STAFF REPORT FOR THE PLANNING COMMISSION MEETING OF MAY 27, 2015

FILE NO: SUP-15-038 AGENDA ITEM: F-4

REQUEST: A Special Use Permit to allow modification of certain Downtown Mixed Use Development Standards, CCMC 18.16, Division 6, pursuant to the alternative compliance provisions of CCMC 18.07.020, including provisions related to project height (building envelope standards), percentage of retail space around the Building A parking structure, and sidewalk width for the development of an office, retail-commercial, and hotel development project known as the Capitol Mall project.

6.7 Building Envelope Standards.

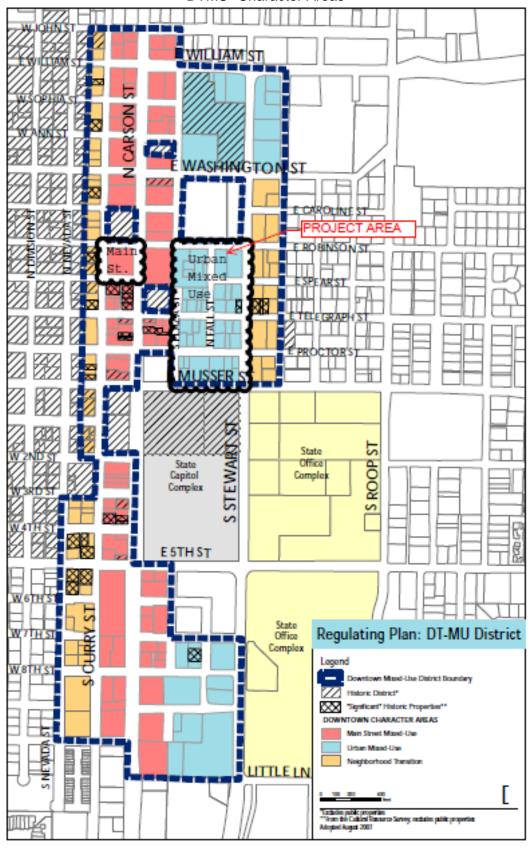
<u>Building A</u> – The DTMU standards permit a total of up to 60 feet in overall height, with 36 feet permitted at the street frontages. Building A is proposed with a building frontage height of 39 feet 6 inches at the corner of Robinson and Curry Streets, 43 feet 6 inches at the corner of Curry and Spear Streets, 47 feet 6 inches at the corner of Carson and Robinson Streets, and an elevator tower at 55 feet 6 inches at the corner of Carson and Spear Streets. Most of the structure (excluding the elevator tower) exceeds the permitted frontage height by approximately 4 to 12 feet, with none of the structure exceeding the total permitted height of 60 feet.

<u>Building B (Hotel)</u> – The DTMU standards permit a total height of 95 feet at this site. Building B is proposed at 110 feet 6 inches in height, with the elevator tower at 123 feet. As the plans indicate, the taller portions of the building only occupy a portion of the block, primarily fronting on Stewart and Robinsons Streets. The building is setback approximately 30 feet from the front property line on Stewart Street and approximately 22-23 feet from the property lines on Robinson and Spear Streets. An open plaza area with no buildings is provided on the west end of the property.

<u>Building C (Office/Conference)</u> – The DTMU standards permit a total height of 95 feet at this site. Building C is proposed at 113 feet 6 inches in height, with the elevator tower at 130 feet. The building has staggered setbacks at the east and west ends of the building, with property line setbacks on the Stewart Street side from 30 feet to 55 feet. The building would be 90 feet from the Plaza Street property line. The building would be approximately 24 feet from the Spear Street and Telegraph Street rights-of-way. An open plaza area with no buildings is provided on the west end of the property.

<u>Building D (Garage/Retail)</u> – The DTMU standards permit a total height of 95 feet at this site. Building D is proposed at 81 feet 6 inches in height, with the elevator tower at 93 feet. The building is approximately 28 feet from the Stewart Street property line and 90 feet from the Plaza Street property line. However, this building would be located at the property lines along Proctor and Telegraph Streets, with no building setback above 36 feet in height, and a reduction in the right-of-way width will be required to accommodate the building. A recommended condition of approval regarding the right-of-way abandonment is included. The Engineering Division supports the proposed abandonment of a portion of the right-of-way to accommodate the building. An open plaza area with no buildings is provided on the west end of the property.

<u>Building E (Office)</u> – The DTMU standards permit a total height of 60 feet at this site. This is an exception to the height standards within the Urban Mixed-Use area of the DTMU district, which reads: *Maximum height on blocks between Proctor and Musser Streets … is 60 feet to preserve views to Capitol* (6.7.B).* Building E is proposed at 85 feet 6 inches in height, with the elevator tower at 102 feet. The building has staggered setback at the east end of the building, with property line setbacks on the Stewart Street side from 30 feet to 55 feet. The building would be 90 feet from the Plaza Street property line. The building would be approximately 25 feet from the Musser Street property line and approximately 20 feet from the Proctor Street property line. An open plaza area with no buildings is provided on the west end of the property.

As the above information indicates, the buildings are generally "stepped down" in height as they get closer to the State Capitol grounds. To meet the intent of the DTMU building envelope standards, the applicant is proposing to keep an open corridor running north from the State Capitol building in the form of a public plaza. This provides open view to the Capitol Building and recognizes its importance to the community. The applicant has shifted permitted height and density towards Stewart and Robinson Streets rather than construct lower buildings within the permitted building envelopes—which would not require approval of a Special Use Permit—in order to provide public spaces.
